Feedback to the 2025 IDRC Review Report: Electromagnetic Calorimeter

Yong Liu (IHEP), for the Ref-TDR ECAL team
August 18, 2025

Colour Scheme
Blue: IDRC Review
Black: Feedback

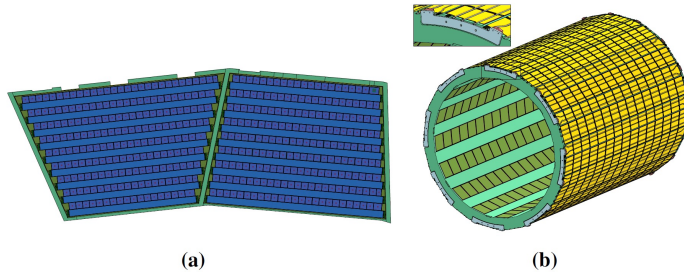
- Advance preliminary engineering of the gaps between modules and fully assess their impact on reconstruction performance.
 - Engineering designs have been significantly updated in **Section 7.2.5 (page 224-230)**, including readout boards, mechanical structures, cooling pipes and plates
 - EM performance have been updated in **Section 7.3.4 (page 238-239)**
 - An energy-correction algorithm has been developed to correct cluster energy loss in module gaps
 - Incident photons are uniformly distributed around ECAL modules including module gap regions

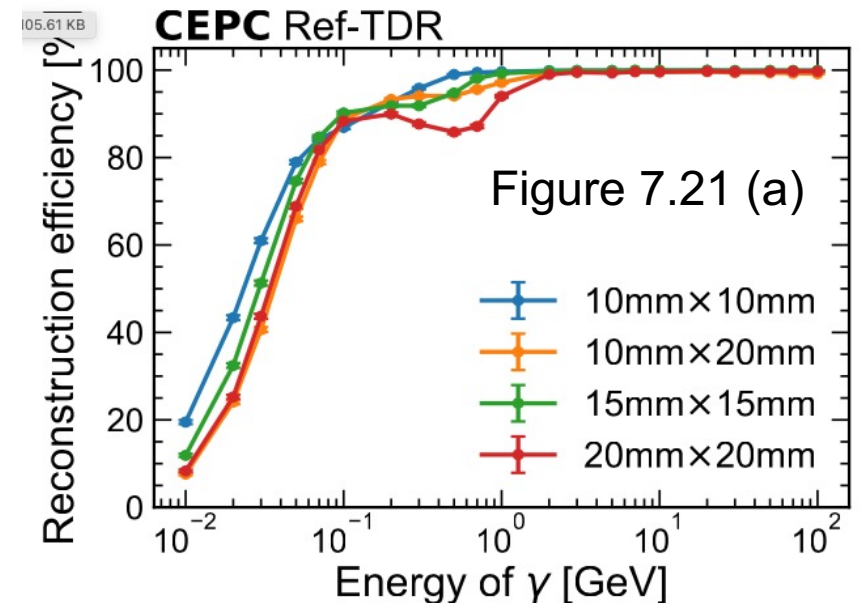
- The ECAL standalone energy reconstruction requires an energy threshold of 0.1 MIPs (as shown in Fig. 7.17), whereas the PFA jet reconstruction, based on fast simulation, adopts a higher threshold (Fig. 8.2). The ECAL team acknowledges the need to further develop and refine particle flow algorithms, photon identification at low energies, and π^0/γ separation to fully exploit the calorimeter's potential.
- Feedback
 - Updated CyberPFA for photon reconstruction
 - Descriptions are updated in **Section 7.3.2 (page 236)**
 - Achieved significant performance improvement, esp. in low-energy regions
 - π^0/γ separation: updates in **Section 7.5.1 (page 255)**

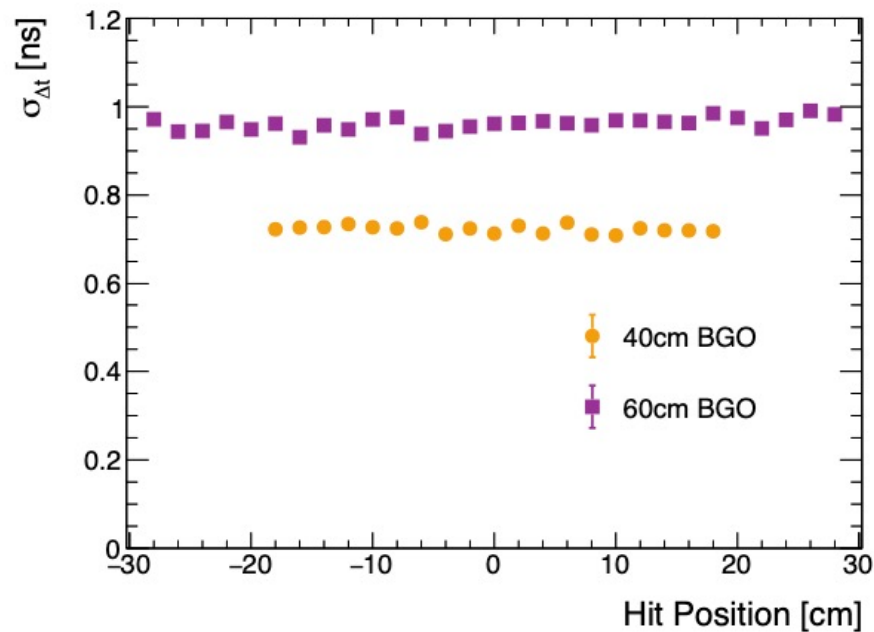
- The discussion about timing performance (Section 7.4.3) remains confusing. The time resolution is defined as “the standard deviation of the time difference of the time stamps of SiPM signals from the two ends of a crystal”. This quantity is not independent of the hit position and does not correctly quantify the precision with which the position of a deposition can be reconstructed. A deposition in the centre of the bar, would give a $\Delta t = 0$ with an RMS from the resolution of the device. A deposition near the ends of the bar would give a distribution with the same RMS centered at $\Delta t = \pm L/2v$, where L is the bar length and v the velocity of the light in the crystal. For a uniform hit distribution, the RMS will therefore get a contribution from the propagation path of $L/(v \sqrt{12}) \sim 0.6$ ns for $L=40$ cm, $v = 1.5c$. This should be added in quadrature to the genuine time resolution from the detector and readout. In Fig. 7.31 at $L=40$ cm, the resolution is 0.7 ns, which is consistent with 0.6 ns from propagation (+) 0.4 ns intrinsic to the detector, which you can read from the measurement with $L=2$ cm crystals. At $L=60$ cm, your measured resolution is almost 1 ns, which is again consistent with an $L/(v \sqrt{12}) \sim 0.9$ ns (+) 0.4 ns. So, while your data show the expected behaviour, your interpretation of the results is different. At L 6602, you conclude that at $L=40$ cm, the resolution is 700 ps (500 ps per end), while your data indicate a resolution is 400 ps/MIP (280 ps per end), which would scale to a resolution of 100 ps already at 200 MeV (per crystal). A better measure of the time resolution is provided by the RMS of the sum of the two timestamps, because the sum of the two propagation times is independent of the hit position. A plot of this quantity should clarify what is the actual resolution. You may still have some dependence on the bar length, because the light output is lower for longer bars.

- Updates in **Section 7.4.3 (page 245-246)**
- We have thoroughly re-analyzed the testbeam data using the definition in TDR (i.e. $T1-T2$) and the alternative definition suggested in the IDRC review ($T1+T2$). Plots are presented in the next page (also in the reference cited by the TDR).
- Conclusions: (1) the 1-MIP timing resolution along the crystal length is uniform; (2) the 1-MIP timing resolutions using two definitions mentioned above are mostly the same.
